Subject: Liquid Hydrogen Cold Source for the NIST Reactor

**RESPONSES TO REVIEW QUESTIONS ON
NATIONAL INSTITUTE OF STANDARDS AND TECHNOLOGY
LIQUID HYDROGEN COLD NEUTRON SOURCE PROPOSAL**

Figure 1. Schematic of fill and removal connections to the proposed NIST hydrogen cold source.

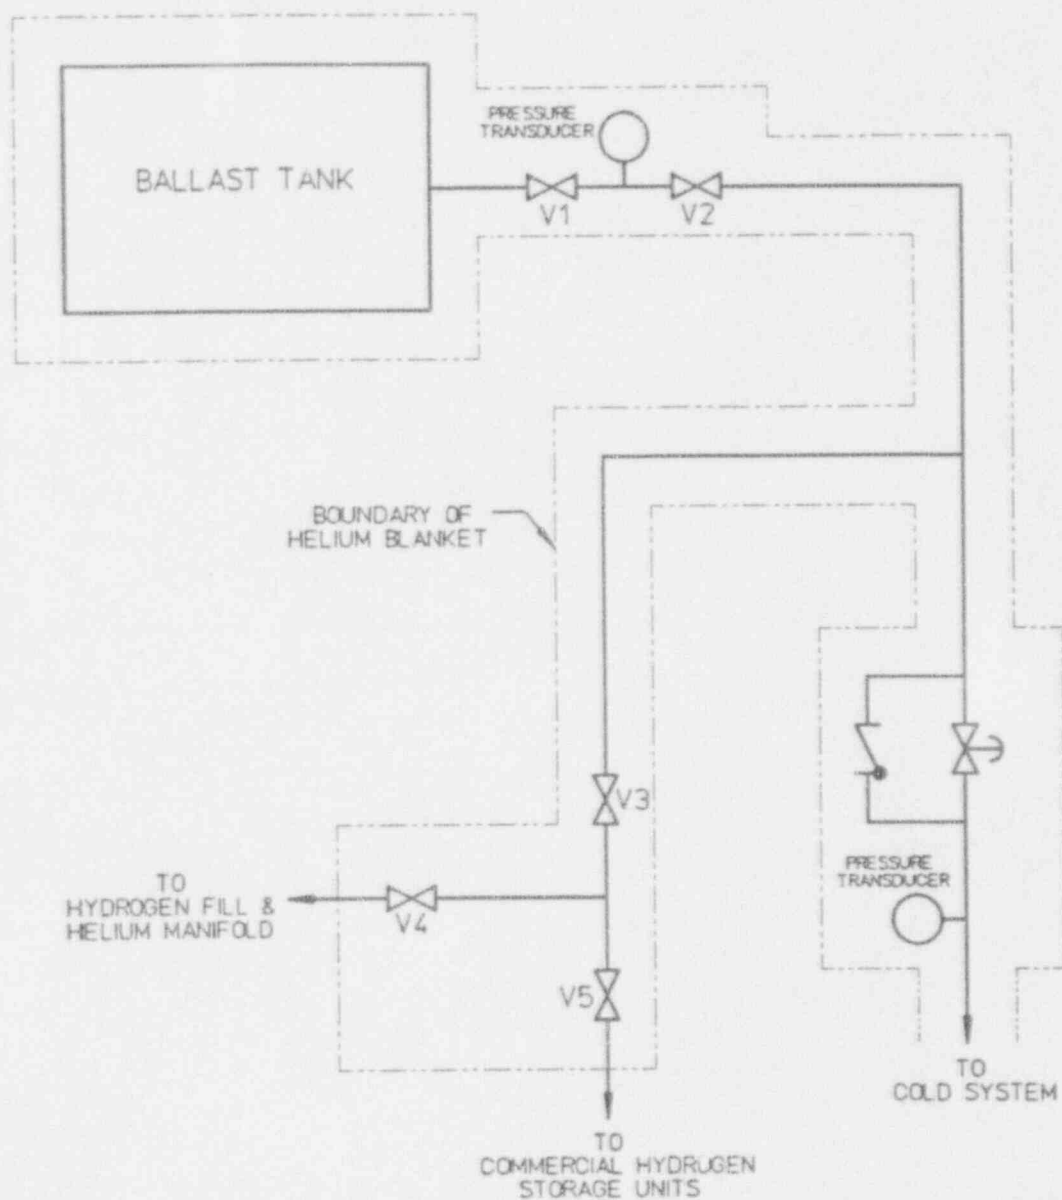
2. The design description provided discusses control and monitoring of the hydrogen vapor absolute pressure. How is the absolute pressure controlled? What control and monitoring equipment is installed?

3. There are two areas where credible accidents may not have been considered, and were not addressed in the submittal:
 - a) When all of the hydrogen inventory is contained in the Ballast Tank during shutdown, the only barrier between this contained volume and the remainder, is a check valve and a solenoid valve, which the reviewer assumes are in a parallel configuration. In the event of a failure of either valve to close, all 500 g of hydrogen could be released into the system. In the event of a failure of the check valve to open, the hydrogen could be

- b) Detailed description of the process and equipment used during absorption of the Ballast Tank inventory into a metal hydride, and final removal from the confinement was not included in the submittal. Please provide a detailed description of the equipment and features involved which would prevent a release of the ballast tank inventory into confinement during this activity. Please provide the following information:

The pressure monitoring equipment consists of two absolute pressure transducers which are attached to the ballast tank and to the line to the source on either side of the valves in this line (see Fig. 1). The transducers are located in the helium containment space, and connection is made by means of capillary tubing with an internal diameter of 0.25 mm (.010 in.) so that if left open, the maximum flow rate of hydrogen with 5 atmospheres driving pressure is less than 6.0×10^{-5} STP m^3/s or 5 mg/s. Under operating conditions, this leak would be into the helium blanket, and so would have no consequences. Even if the helium blanket were open to air for maintenance, and the leak were into the confinement building, hydrogen diffusion and building ventilation are sufficient to prevent accumulation of a significant volume of a hydrogen-air mixture within the flammable concentration limits. At the same time, the connecting tubing will not significantly slow the response of the transducers to pressure changes in the hydrogen vapor. These pressure monitors are the only instrumentation in the hydrogen loop, and permit testing of all system valves as discussed above. The outputs from the transducers are monitored by visual readouts and electronic systems. The pressure is controlled during source operation by use of the monitored signal as an input to the refrigerator control system. In responses to changes in the hydrogen pressure, the control system positions a proportioning valve in the line supplying helium to the condenser. This loop allows the system to adjust to changes in heating rate during reactor power changes, which is the only mechanism that exists to perturb the steady state operation at constant pressure (and therefore constant temperature of the liquid hydrogen). This system is needed to assure the proper operation of the liquid hydrogen as a cold source, but is not required for reactor protection. In the event of a refrigeration failure, this pressure will rise as the hydrogen boils off, and at a preset level, an alarm will alert the reactor operators to the problem. They would then shut down the reactor, *in order to protect the experiment*, rather than for the safety of the reactor. If the reactor were not shut down, the moderator chamber would warm up to temperatures in excess of 600 K. At this temperature, the moderator vessel yield strength would be reduced somewhat, but even if it ruptured, the vacuum and helium containment vessels would contain the hydrogen released. There are therefore no reactor related safety issues arising from this system.

- There will be two manual isolation valves in series at the ballast tank (see Fig. 1 and discussion in response to part b of this question below). With these valves installed, the check and solenoid valves could be deleted from the system, with no safety impact.

removal system for the source are shown in Fig. 1. The design philosophy is to maintain at least two barriers between the large volume of hydrogen in the ballast tank and the confinement building at all times. Thus, there are two manual isolation valves in series between the ballast tank and the remainder of the system (V1 and V2). The line which connects to the hydrogen fill and removal manifold has a valve V3, followed by a tee running to valves V4 & V5. As indicated, all of these valves are enclosed in the helium blanket to provide double barriers. In normal operation, V1 and V2 are open, and V3-V5 are closed, with the connecting lines either evacuated or filled with helium. The metal hydride system would be connected to V5, and the line between V5 and the hydride system valves filled with helium. In order to remove the hydrogen from the portion of the system external to the ballast tank, V1 and V2 would be closed, the solenoid valve would be opened, then V3 and V5 would be opened, and finally the valve on the storage system would be opened. Emptying would be verified by observing the pressure gauge on the appropriate side of V1 and V2, which also tests the leak tightness of V1, V2. If the whole system were being emptied, V1 and V2 would be opened *after* observation of proper action of the metal hydride system in evacuating the volume external to the ballast tank.
